Re: Chicopee Levee Slope Stability – Response to USACE Comments
Uniroyal Filling Project
Chicopee, Massachusetts

Updated Geotechnical Analyses
Slope Stability
Uniroyal Site Filling Project
Chicopee, Massachusetts

REVIEW COMMENTS

Project Name: Former Uniroyal-Facemate Property Filling Project	Date: 23 September 2020
Location: Chicopee, MA	Reviewers: Kevin DiRocco/ Patrick Blumeris
USACE ICW Project: Chicopee Riv LB - Chicopee Falls, MA	
Documents Reviewed: (1) Stormwater Management Report, Former Uniroyal & Facemate Properties, Chicopee, MA, dated July 2020 (Marked ACOE Permit Only) (2) Figure No. 3 through No. 11, dated July 24, 2020 titled: Former Uniroyal & Facemate Properties (Marked ACOE Permit Only) (3) Letter report prepared by O'Reilly, Talbot & Okun Associates for BETA Group, titled Chicopee Levee Slope Stability, Uniroyal Filling Project, dated Sept. 14, 2016. (4) Letter report prepared by O'Reilly, Talbot & Okun Associates for BETA Group, titled Chicopee Levee Slope Stability, Uniroyal Filling Project, dated Sept. 29, 2017	
Submitted By: BETA Group	Submittal Dated: Varies

Enlarged Grading & Drainage Plan II
Uniroyal Property

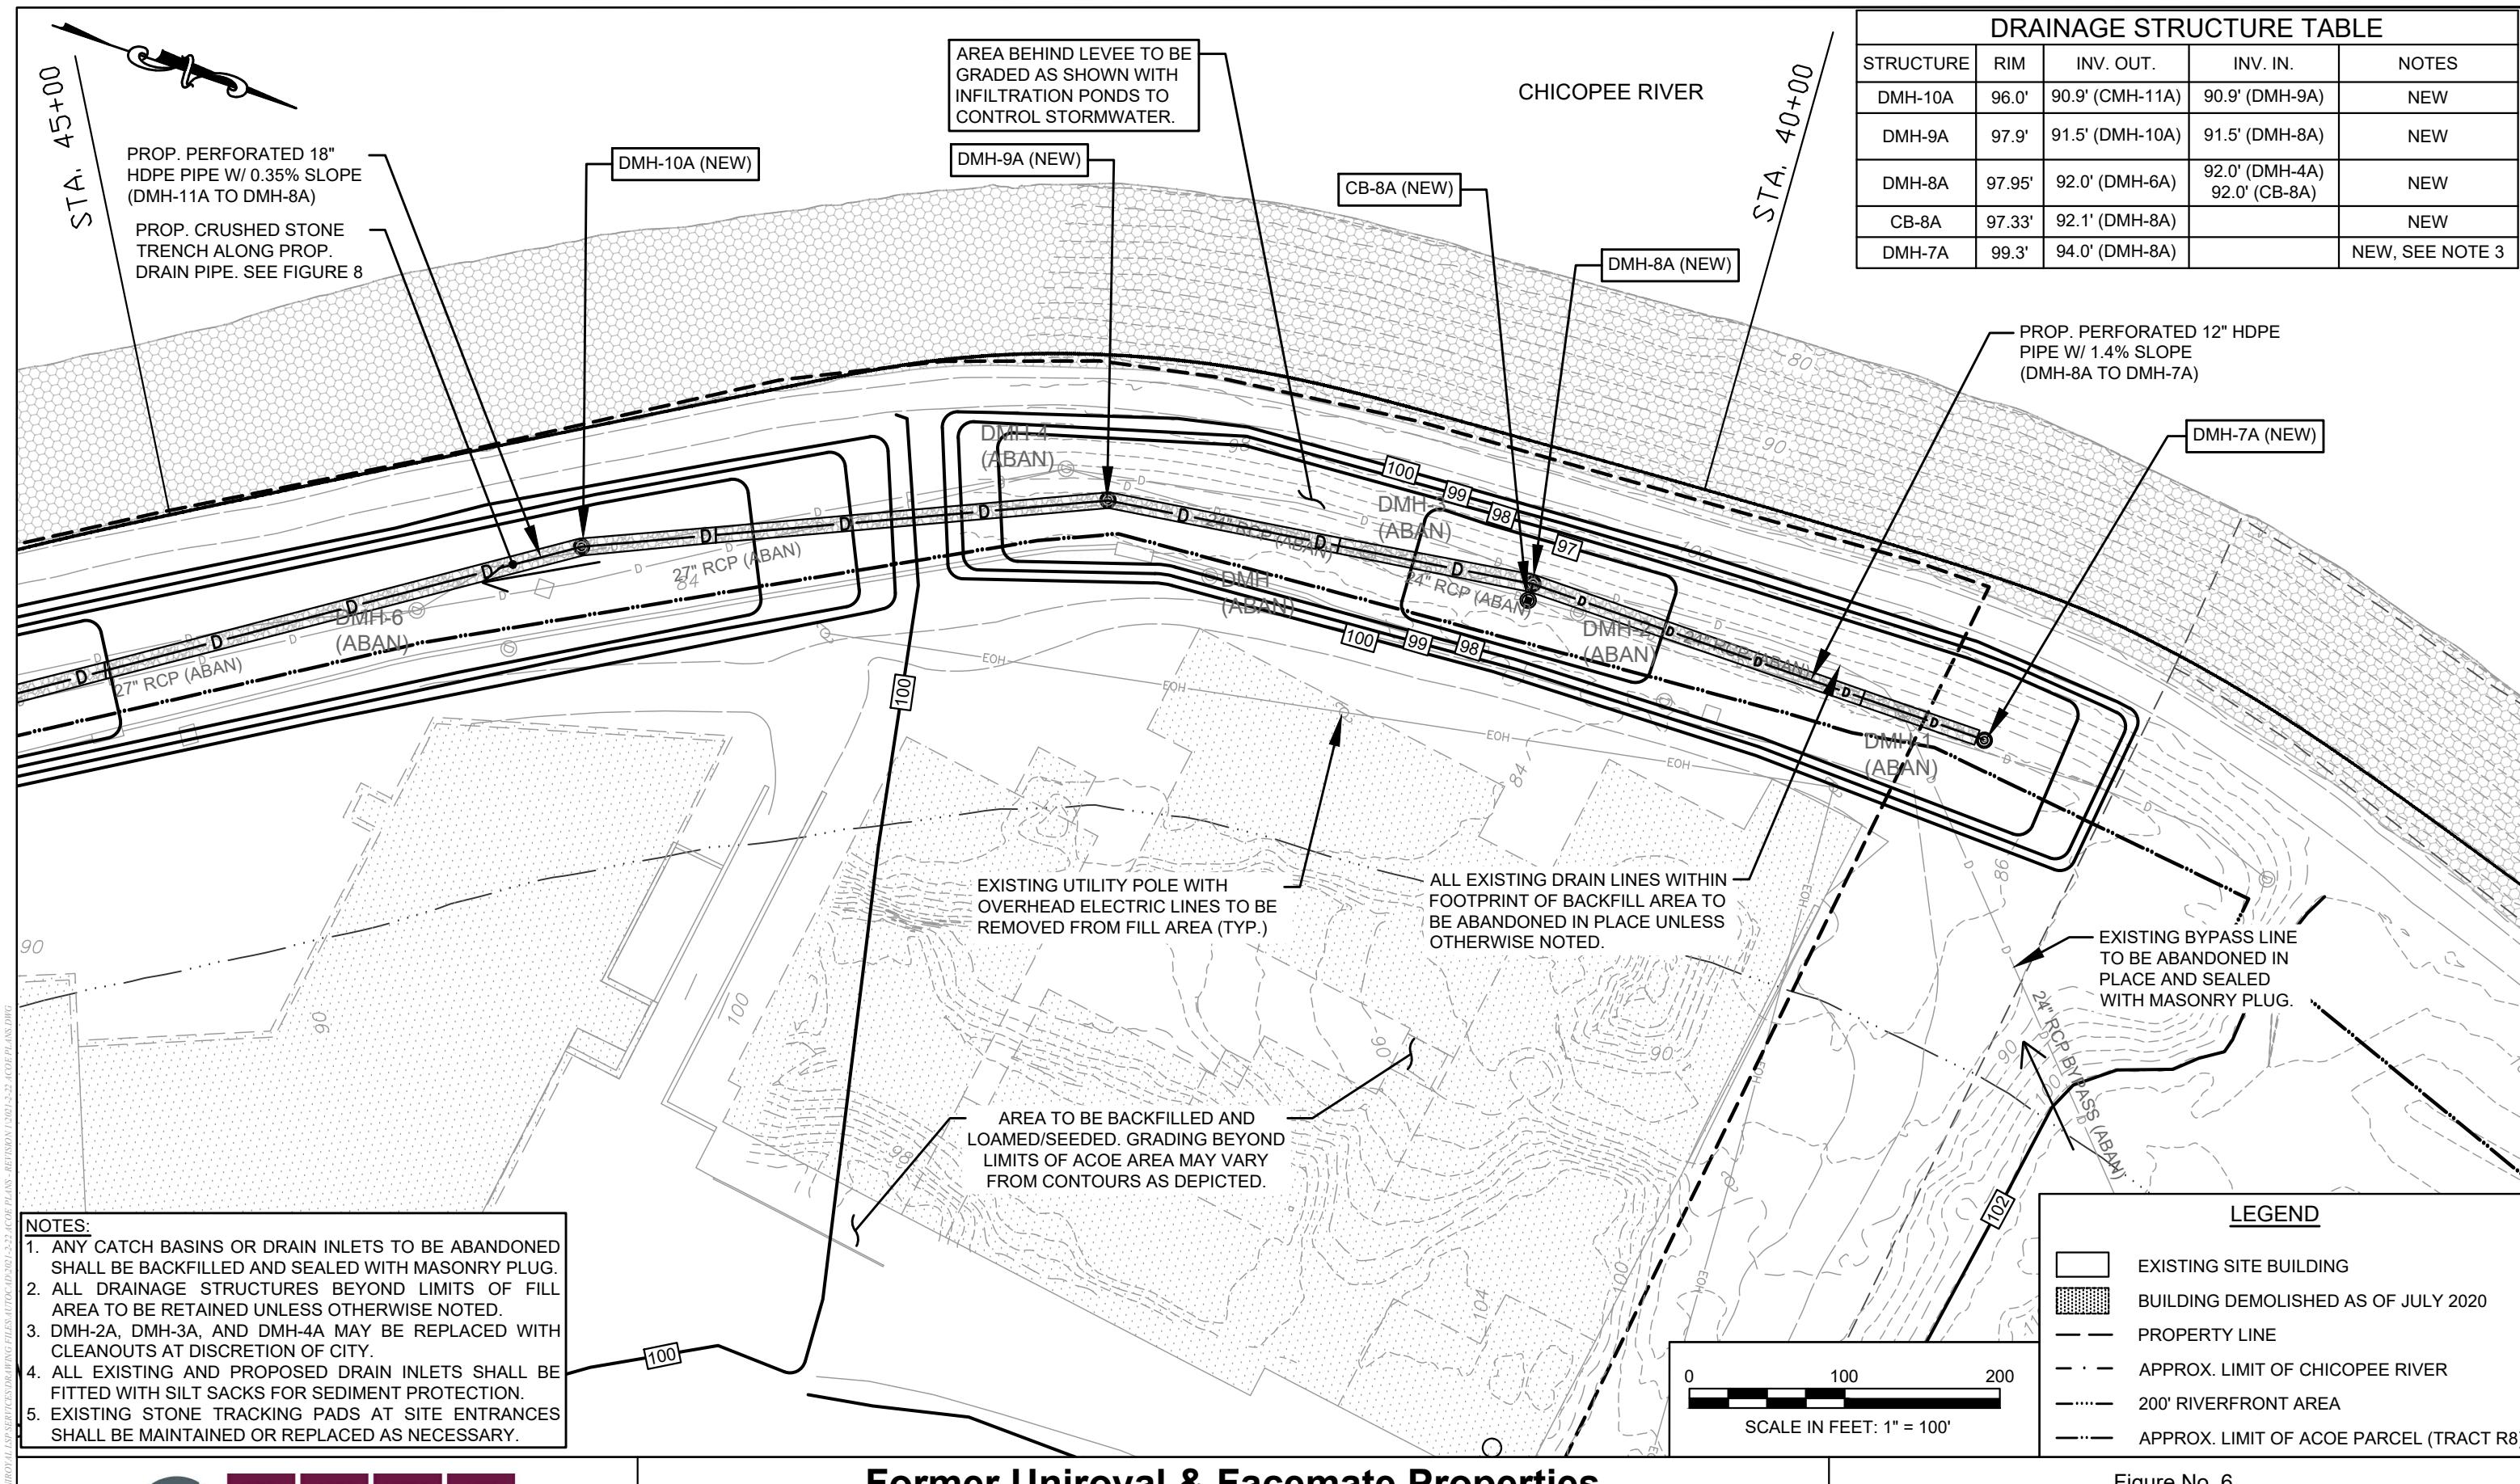
19.	Doc. Nos. 3&4	<p>The current plan calls for construction of infiltration basins immediately landward of the levee embankment. The Stormwater Management Report suggests that the proposed infiltration basin will be filled with water during an extreme event. For the stability analyses, the landside groundwater level for both cross sections evaluated should either be assumed to be at or near the top of the levee embankment, to reflect the maximum estimated water level in the infiltration basin during the design storm event, or a seepage analysis or other evaluation is required to justify a lower anticipated phreatic surface in the embankment and landside fill prior to rapid drawdown.</p>

19. The analysis has been revised to include the construction of the new infiltration basins on the landward side of the levee embankment. These basins are shown on the attached project plans (Enlarged Grading & Drainage Plan I, II – Figures 5 and 6; and Grading & Drainage Plan – Figure 7). As seen on these plans, a catch basin is present within each of these basins. These catch basins allow water within the basins to drain relatively quickly during the design storm event. Each catch basin is connected through a manhole into an 18 or 24 inch perforated drainage line, which is placed within a crushed stone trench. These drain lines follow the alignment of the embankment and discharge into existing drains at both the upstream and downstream ends of the project. The new drain lines are of sufficient size to drain quickly. Since the drain pipes are perforated and installed within crushed stone trenches, they will function like toe drains and thus lower the water level within the fill and existing levee embankment.

CASE 3
Station 13+30 - Modified Standard Project Flood Rapid Drawdown

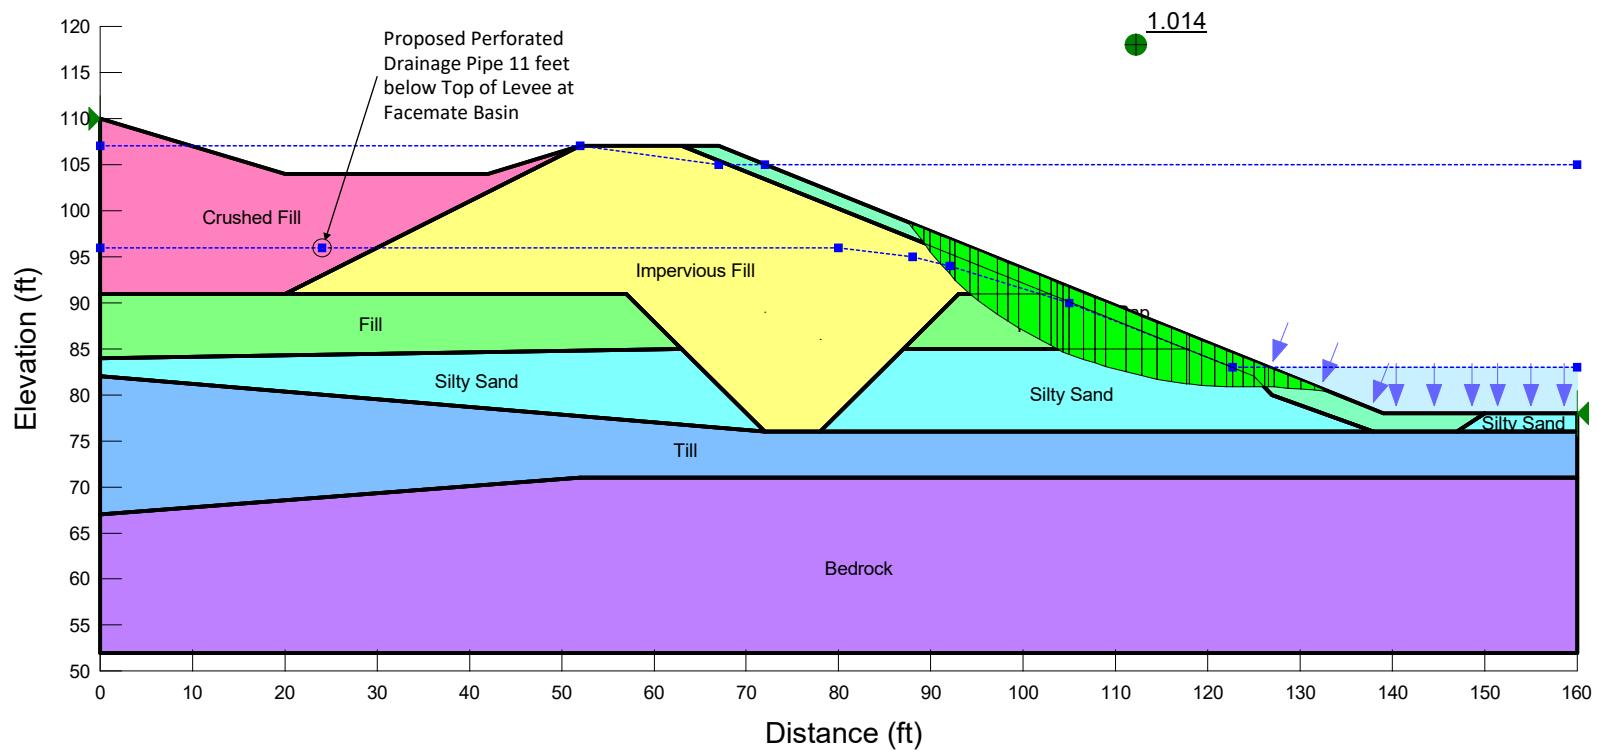
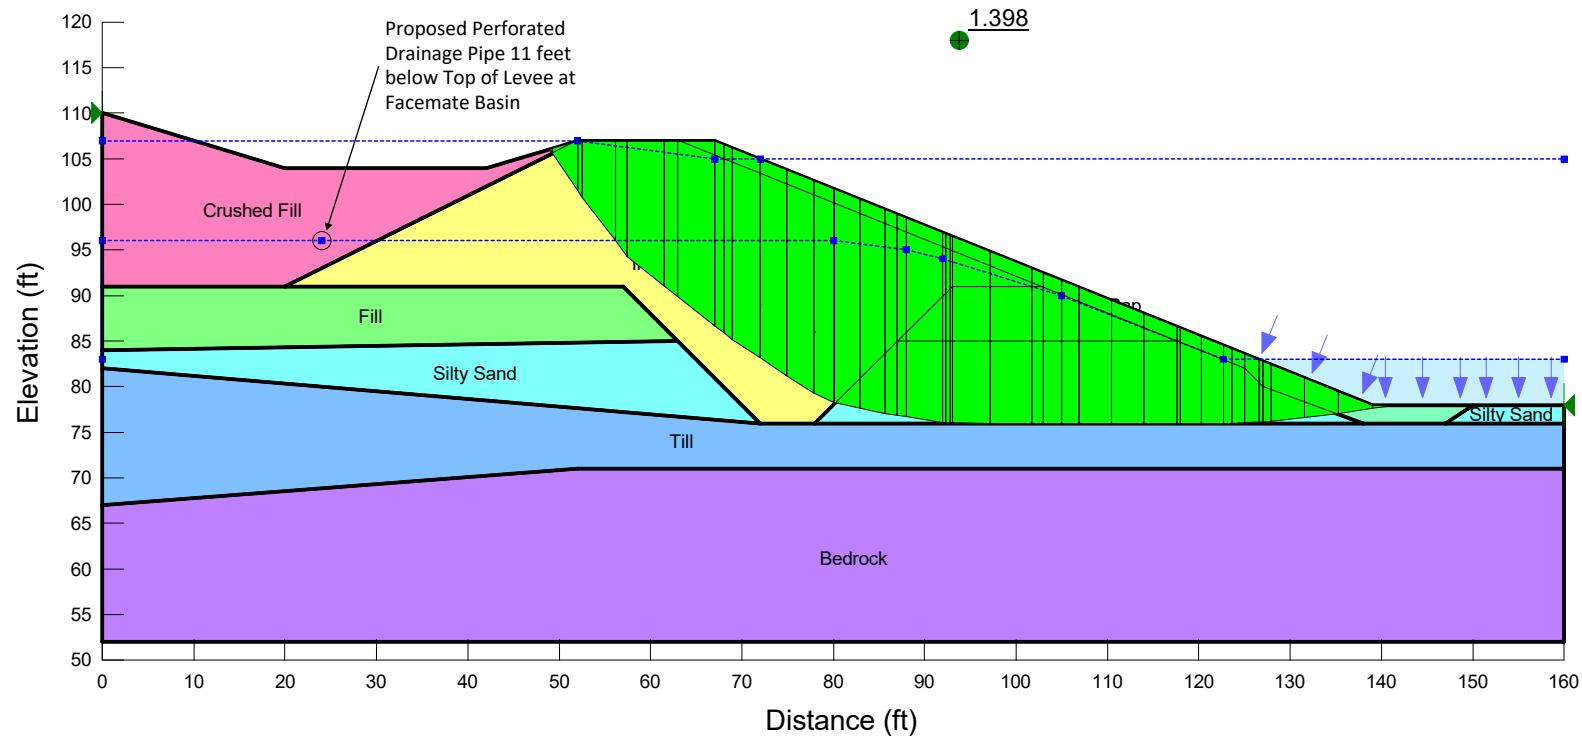
17.	Doc. Nos. 3&4	<p>The stability report indicates that the rapid drawdown analyses were performed using the USACE 3-Stage Method. However, only drained strengths are provided in the report, which only applies to the first stage of the analysis. Provide the undrained strengths and final strength envelope used for the second and third stages of the analysis.</p>

17. The sections were analyzed for three separate conditions, per the USACE manual: rapid drawdown (performed using the USACE 3-stage method¹), long term (steady seepage during 100-year flood conditions), and normal water conditions. In each of these cases, effective strength parameters were used. In the rapid drawdown case, both effective and total were used as part of the 3-stage method. As noted in our September 14, 2016 letter, the soil properties were consistent with those previously used by GZA in their report dated November 2010. Copies of the appropriate pages of the GZA report showing the soil properties used are attached. These properties are consistent with the Soil Properties table provided in our September 14, 2016 letter.

Case 3, 7: The analysis titled “Modified Standard Project Flood Rapid Drawdown” identified multiple factors of safety for the levee during the rapid drawdown scenario, the lowest factor of safety identified is presented. In this case, the critical failure surfaces were relatively shallow and located along the surface of the levee. It does not appear the crushed fill will impact the levee as these results are similar to the results provided in GZA’s report.
